REZONING APPLICATION ANALYSIS

ZONING CASE #: Z2025-17

REQUEST: PRD-SF (Planned Residential Development, Single-Family)

REASON FOR REQUEST: To construct up to 119 single-family homes
(detached and attached/townhomes)

Zoning
Concept
Plan

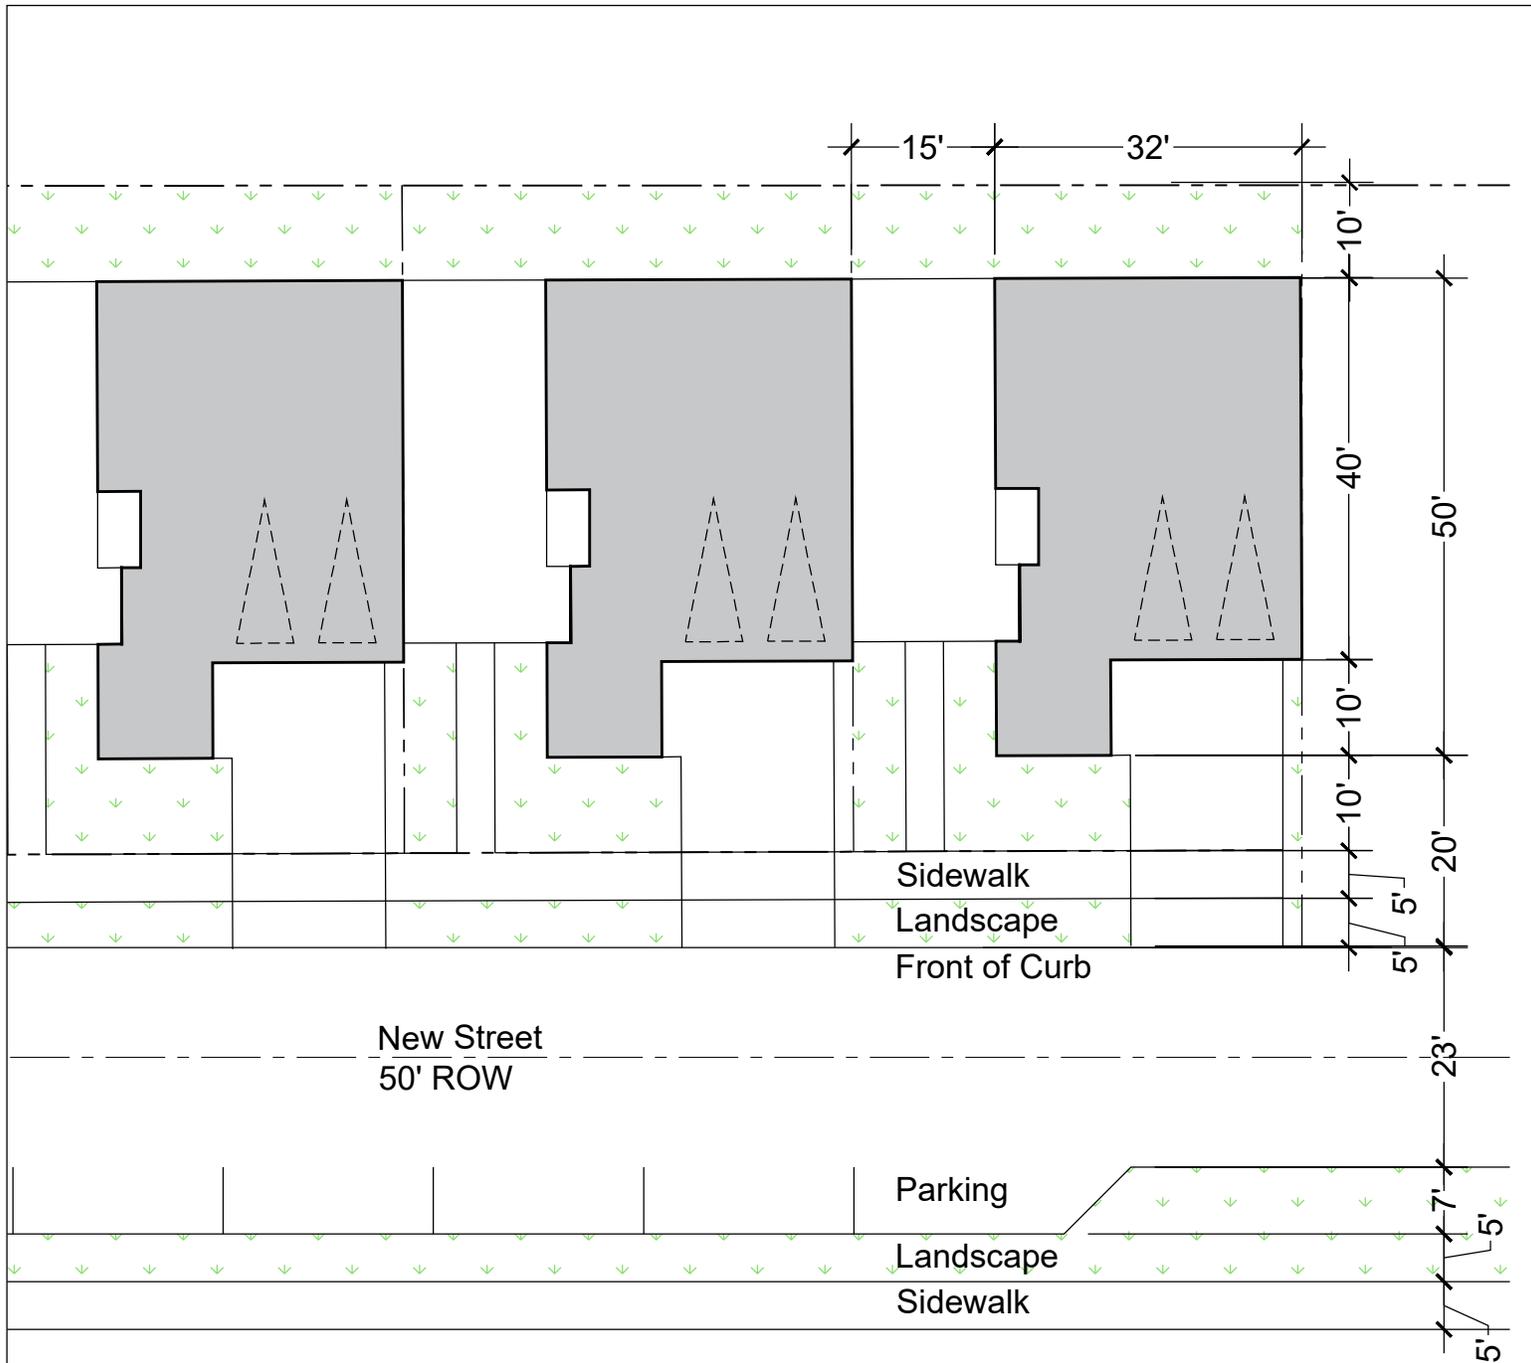
Both detached single-family homes and townhomes are proposed in the new development. While the application states 119 units will be built, the site plan shows 113. These numbers will have to be clarified. As illustrated in the site plan, however, the unit breakdown is as follows:

- **Natural areas are respected.** All homes are shown to respect stream buffer limits (though they will need to be penetrated for the sake of a street connection). Homes are also situated around green spaces, demonstrating their value to the development.
- **The concept is designed to incorporate green spaces and amenities,** paying equal attention to the location of open space as that of the proposed homes. Sometimes, plans for PRD-SF developments include neighborhood green spaces and amenities as an apparent afterthought – placed into corners on unbuildable land. Ill-designed and located open spaces and amenities – rather than simply being underutilized - can detract from a neighborhood, becoming eyesores if poorly maintained.

- **Homes are well-situated.** Land to accommodate parks and green spaces is incorporated, likely without sacrificing unit count, due to the proposed “alley loaded townhomes.” These townhomes are clustered together on the plan, claiming relatively small portions of the site, rather than being spread out on larger lots. The space-saving is gained from the units being served in most instances only by 16-foot alleys to the rear. Such an arrangement, however, is not supported by zoning code, which states that alleys should only be included within developments as a secondary means of access to the rear or sides of buildings and should not be substituted as a primary street. Other traffic engineering requirements of the Engineering and Fire departments may end up trumping this design solution, however.

Two (2) access points are required for developments containing more than 51 residential units, which the concept plan reflects. However, code stipulates that connections should be to arterial or collector streets, whereas the only possible connections in this circumstance are to local streets.

All homes feature two-car garages, satisfying code, but driveways of the alley loaded townhomes (52 units) measure only approximately six (6) to seven (7) feet long. All other driveways appear to be at least 20 feet long. Guest parking provided (49 spaces) is beyond that required by code (23 spaces). The surplus of 26 guest parking spaces, however, does not fully compensate for the lack of car parking available due to the short driveways at individual alley-loaded townhouses. Without 20-foot driveways, the parking capacity is diminished so that each townhouse unit can only provide parking for two (2) cars rather than four (4). Taking the surplus guest parking into account, this still results in an overall deficit of 78 parking spaces for the development according to code.

The large, undeveloped parcel at 1651 Crestridge Drive contains four (4) billboards along I-75. While the site plan includes these structures, it is unclear whether the applicant intends to keep the billboards or if they are to be removed. The two (2) northernmost billboards are within 75 feet of planned residential units. No information was provided regarding the billboards' sizes.

- Variance to allow private alleys as a primary means of access. [§716.06]
 - ***All developments for which alleys are proposed shall be reviewed and approved by City Council at a regularly scheduled meeting as a separate item on the agenda.***
- Variance to reduce the required width of two-way private alleys from 20-feet to 16-feet of travelway. [§716.06 (B.)]
- Variance to waive the required turnaround for dead-end alleys. [§716.06 (D. & I.)]
- Variance to decrease the percentage of units within 300 feet of an active recreation feature from 75% to 55%. [§708.09 (B.1.h.)]
- Variance to allow the proposed 113 single family units to be accessed off local streets as shown on submitted plan. [§730.01 (A)]
- Variance to reduce the minimum lot size from 4,000 square feet for detached homes as shown on submitted plan. [§708.09 (H)]

- Variance to reduce the minimum size of driveways from 20 feet to accommodate two (2) additional cars to six (6) feet for the alley loaded townhomes (52 units).
[§708.09 (B.1.d.)]

Most of the subject area is undeveloped; therefore, any development on the property will increase water runoff. There are multiple stream branches on the subject property - one (1) which runs parallel to the southern property line and two (2) other streams perpendicular to the southern stream. The Engineering Department identified the streams' drainage basin as Rottenwood Creek. Because Rottenwood Creek is listed as an impaired stream, the site will be limited to 50% impervious surface. As presented, impervious surface across the site was calculated by the applicant to be 50.08%.

The most challenging portion of the site to develop, being blanketed by streams and associated buffers, is located adjacent to the interstate and therefore not desirable for home construction. Developers have chosen to largely avoid conflicts with these waterways, therefore, and leave them untouched to serve as buffers between the new development and I-75. A new street is proposed to cross a stream, however, to bridge two (2) halves of the development separated by the waterway and its buffers. Although not mentioned, it appears City stream buffer

variances would be required due to this crossing. Engineering also states a Corps of Engineers permit may be required if wetlands are to be impacted.
